Meadowbank 2025 Annual Open Pit Geomechanical Inspection Report

RE: Meadowbank Complex - Meadowbank Site - 2025 Annual Open Pit Geomechanical Inspection

Meadowbank Complex - Meadowbank Site - 2025 Annual Open Pit Geomechanical Inspection

Goose Open Pit - Ramp

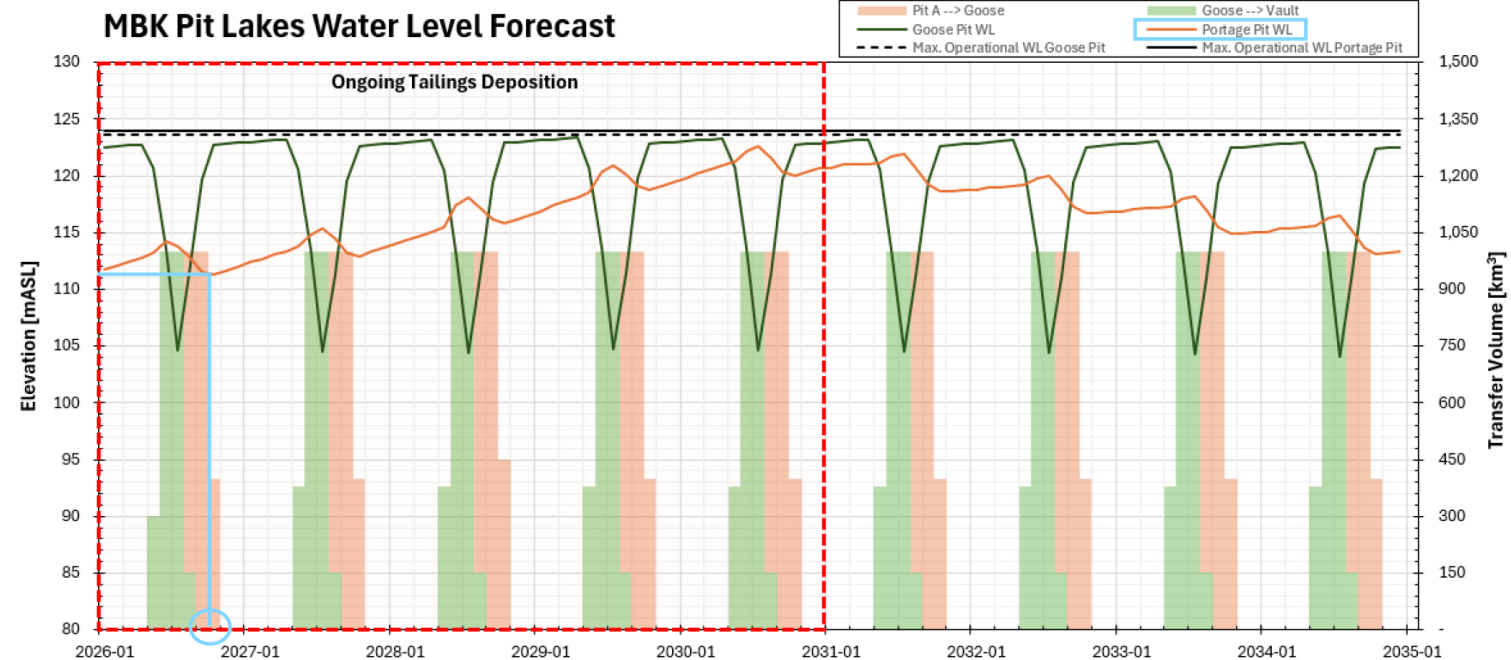
- The access to the pit has been reconfigured and personnel now travel for a short distance along a catch bench to reach a dock on the pit lake. As a result, personnel now travel closer to the uppermost 7 m bench face of the pit. Minor loose was observed on this face, which represents a rockfall hazard. The face should be scaled or a rockfall berm constructed.
- The ramp is clearly sign posted that access is restricted to authorized personnel only.

- The rise of the pit lake elevation has progressively reduced the length of the ramp that is exposed and needs to be managed. The open pit water level is planned to be lowered and raised by 17 to 18 m each year starting in 2026 as part of the water treatment strategy for the mine.
- When the water level is lowered, workers will be re-entering previously flooded portions of the ramp. The condition of the open pit walls will need to be re-assessed and the adequacy of any existing control measures (e.g., rockfall berm) reviewed before access is allowed to the re-exposed areas.

Goose Open Pit - North Waste Rock Dump

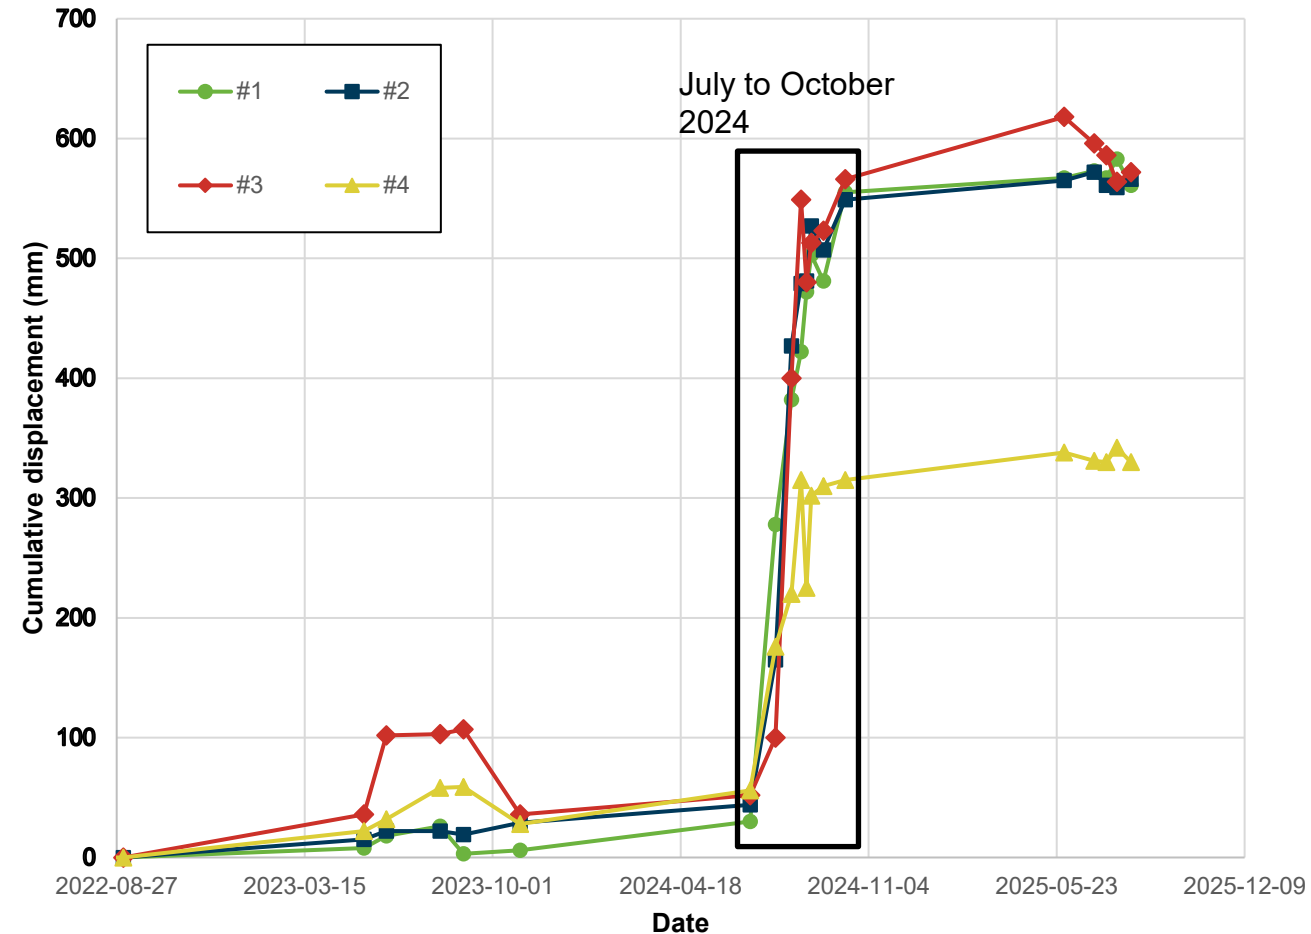
- The dump is inactive, and access is prevented by a rockfill berm and the presence of water pipes at the access point.
- The dump has been subsiding since 2015. The settlement is attributed to the deposition of water in the open pit, through a combination of thawing and increasing porewater pressure.
- The settlement has resulted in a series of scarps along the dump platform, that are now 3 to 4 metres in height (see photo below).
- The settlement is monitored as part of monthly inspections by the Geotechnical Group visually and using four survey pins installed in 2022. The observed deformation is discussed on the following slide.

- The four survey pins are monitored on a bi-weekly basis when the open pit is accessed.
- The cumulative displacement increased abruptly by approximately 550 mm between July and October 2024. Until this point, the deformation rate was less than 1 mm/day. The displacement has since stabilized at less than 2 mm/day.
- The cause of the sudden increase in displacement has not been determined but is believed to be due to the increasing water elevation in the pit lake.
- The observed deformation remained within the TARP Blue (Stable) status. However, as discussed during the previous annual inspection, such a sudden change in behaviour should have triggered a review. The TARP should be updated to reflect this.
- There continues to be a need to better quantify the extents and total deformation. Recommend using InSAR or drone photogrammetry to assess this on a semi-annual basis.

B Dump - General

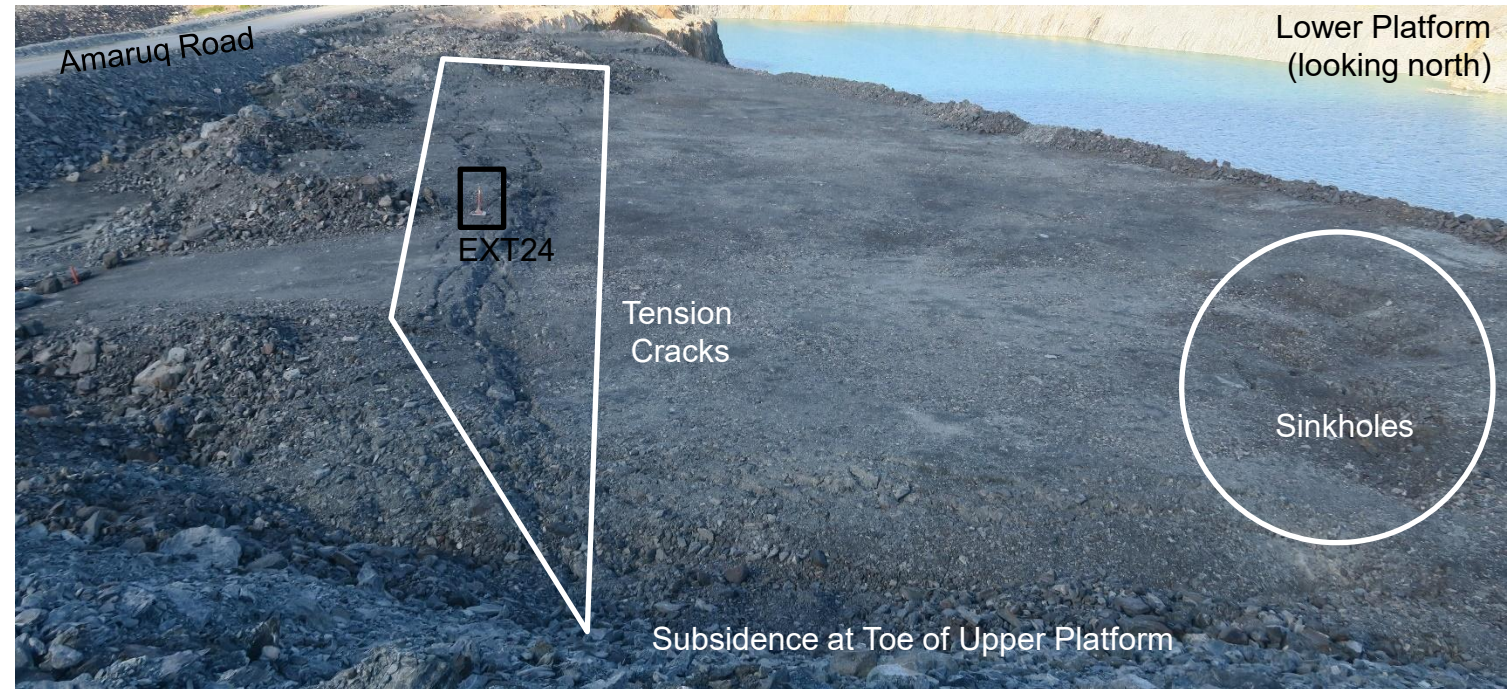
- Tension cracks and subsidence continue to be observed on both platforms. The northern end of the Lower Platform has experienced the most subsidence. Sinkholes have also formed at the southern end of the Lower Platform. These are discussed on the following slides.

- An extensometer has been installed on the Lower Platform, and this is described further on a following slide.
- The possibility of the settlement progressing back to the Amaruq Road (West Road) was discussed in 2022 and concluded to be unlikely as the settlement and tension cracks appear to be limited to within the footprint of the pit. WSP has completed a detailed assessment of the stability of the road embankment as the water levels increase and the embankment was raised as a result. WSP has recommended that the embankment continue to be monitored as settlement is still possible.

B Dump - Upper Dump Platform

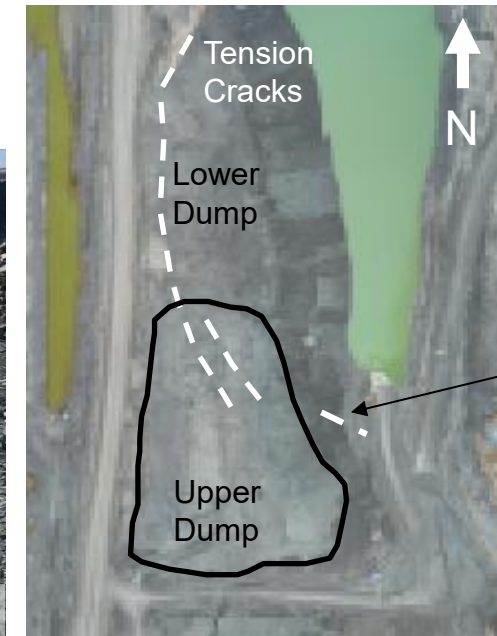
- The NW-SE tension cracks at the northern end of the Upper Platform have continued to increase in number and prominence since the 2024 inspections. Cracks are also now visible on the southeastern corner of the dump. Similar to the lower dump platform, the cracks are thought to be linked to the geometry of the underlying pit slope.

- The northern end of the Upper Platform has experienced settlement since at least 2022. Since 2024, a section of the platform 10-20 m back from the northern crest has subsided further than the platform at the northern crest. The reason for this is unclear. It could be evidence of a rotation of the dump towards the north, but no east-west tension cracks were observed and would be expected to occur under those circumstances.

- Visual inspection are being completed for the Upper Platform. InSAR or drone-based photogrammetry should be used to quantify and better understand the extents of the deformation.

C Dump

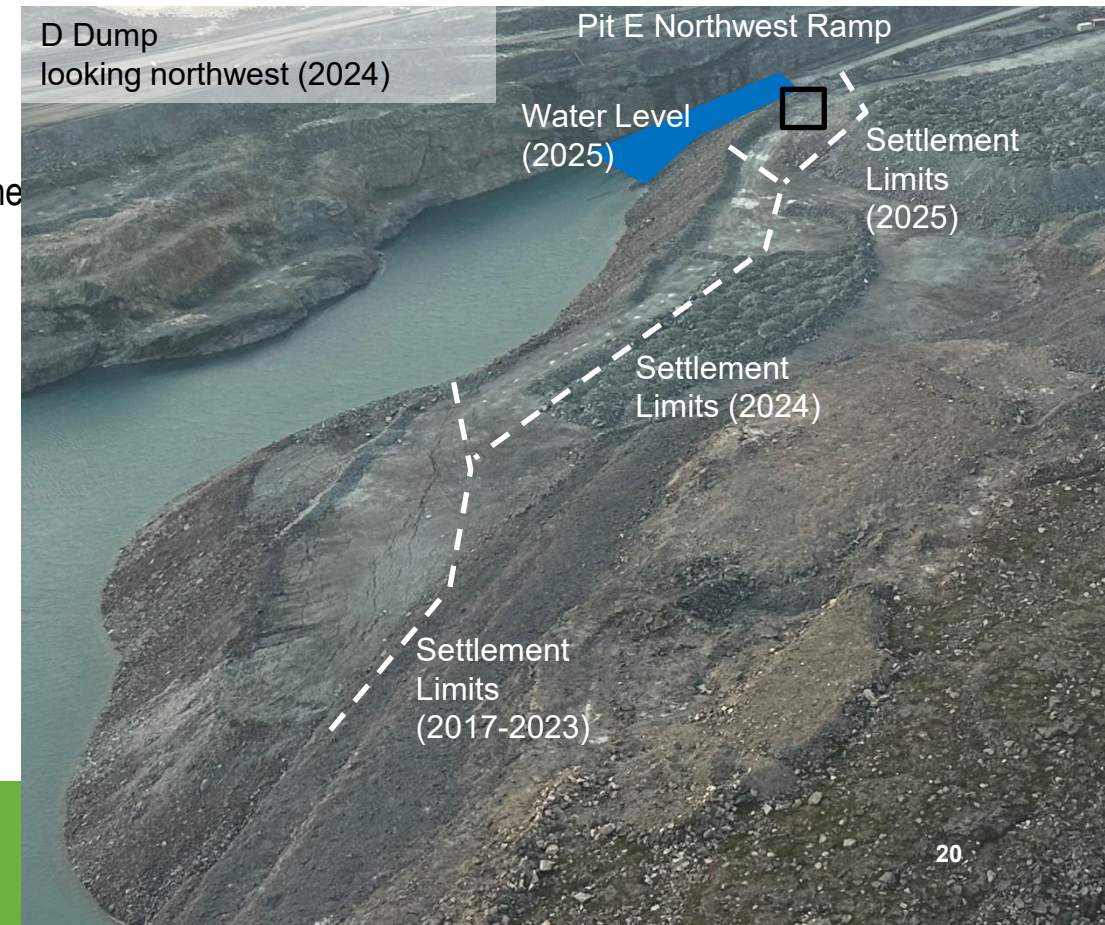
- The C Dump, which backfilled Pit C, is located between Pits A and E and is inactive. Access to the dump platform is permitted but a berm has been constructed approximately 25 m back from the crest of the dump above Pit A. A single junction box remains within the berm.
- Settlement of the dump was expected and remains possible as the water elevations in Pit A and Pit E surpass the base of the dump (approximately 5085 mRL). The water elevations in both pits rose above the base of the dump in 2024 and water is now flowing from Pit A to Pit E below the dump. However, no evidence of settlement or instability has been observed to date.
- The ongoing use of the dump as a laydown is considered acceptable as no evidence of instability has been observed and experience at the other dumps suggests that the settlement is likely to be progressive in nature.

Vault Open Pit - Southwest Wall

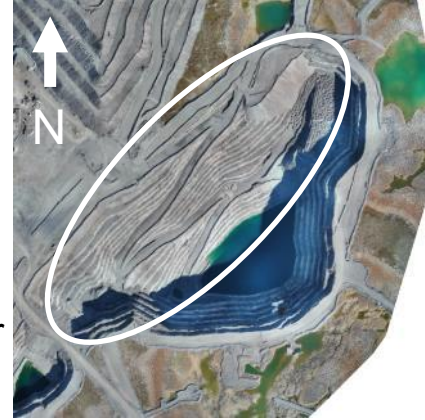
- The Amaruq AWR crosses a saddle between the Vault and Phaser Pits on a rockfill embankment.
- During the winter of 2023, tension cracks were observed on the surface of the road, perpendicular to the axis of the road. The cracks have not been observed since and may have been due to frost heave within the upper road surface.

- No evidence of instability in the AWR embankment was observed during the inspection (e.g., no tension cracks on the road surface or bulging of the embankment toe).

- The stability of the Amaruq AWR embankment could be impacted if the water level in the Phaser Pit on the other side of the embankment increases and water ponds behind the embankment. This has not occurred. Possible minor seepage at the toe of the embankment was observed at the time of the inspection. The presence of seepage should continue to be evaluated as part of the monthly inspections. Recommend noting the importance of this in the GCMP.

Vault Open Pit - North Waste Rock Dump

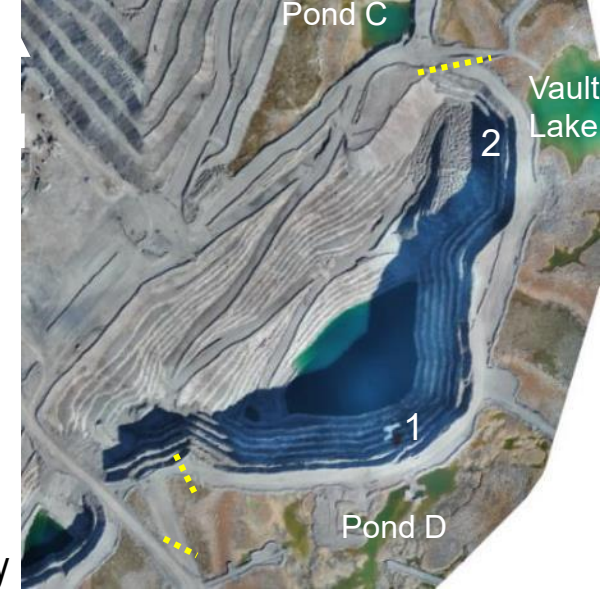
- A waste rock dump was constructed at the north end of the Vault Pit. The dump is inactive and consists of two platforms with elevations at approximately 5133 mRL and 5082 mRL.
- Settlement and tension cracks were observed at the crest of the upper platform at the north end of dump during the 2019 inspection. There appears to have been little change since that time. The affected area is relatively small and is not above the ramp.
- No other evidence of instability was observed during the inspection.
- Access to the dump is prevented with a berm.

Inspections

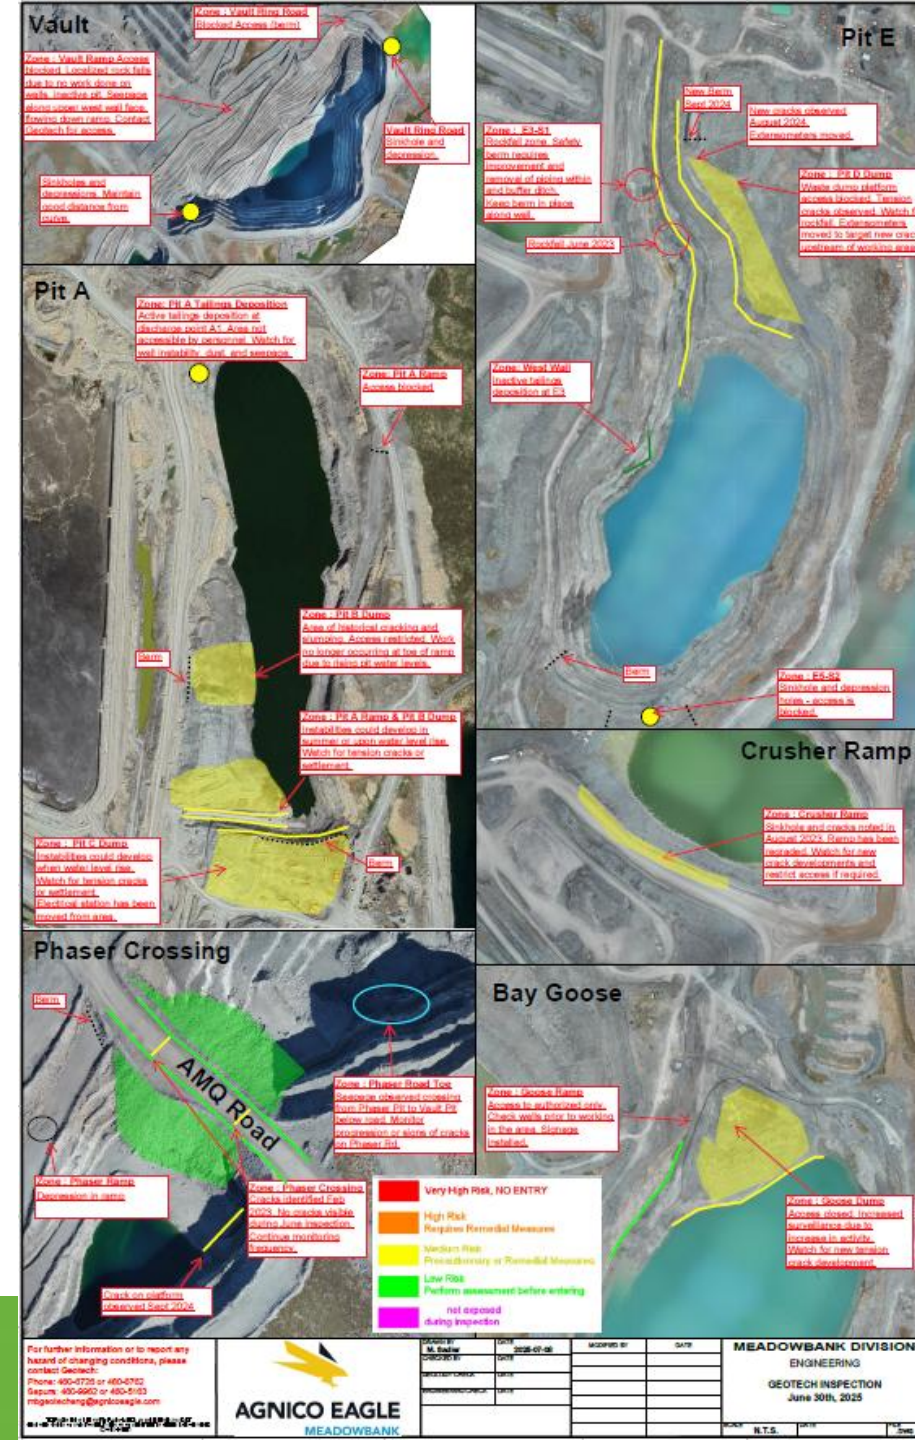
- Visual inspections are completed by the Geotechnical Group on a monthly basis (with some exclusions during the winter between October and February) and a summary report and map issued. The inspection procedure has been updated to define criteria when additional inspections are required.

- The inspections are primarily completed by the site geotechnical engineer.
- The Rock Mechanics Group commits to an over-inspection of the open pits and in-pit dumps at the Meadowbanks site once a year. This is now completed as part of this annual inspection. It is expected that a greater commitment from the Rock Mechanics Group will be required in the future as the pit lake levels are varied and historical instabilities re-exposed.

- The inspection report for June 2025 was reviewed. It was well-written and all but one of the key hazards identified during the 2025 annual inspection was noted. The rockfall hazard along the ramp to the Goose Pit and the ramp to the Phaser Pit was not captured in the report. Future inspection reports should be updated to reflect these hazards.
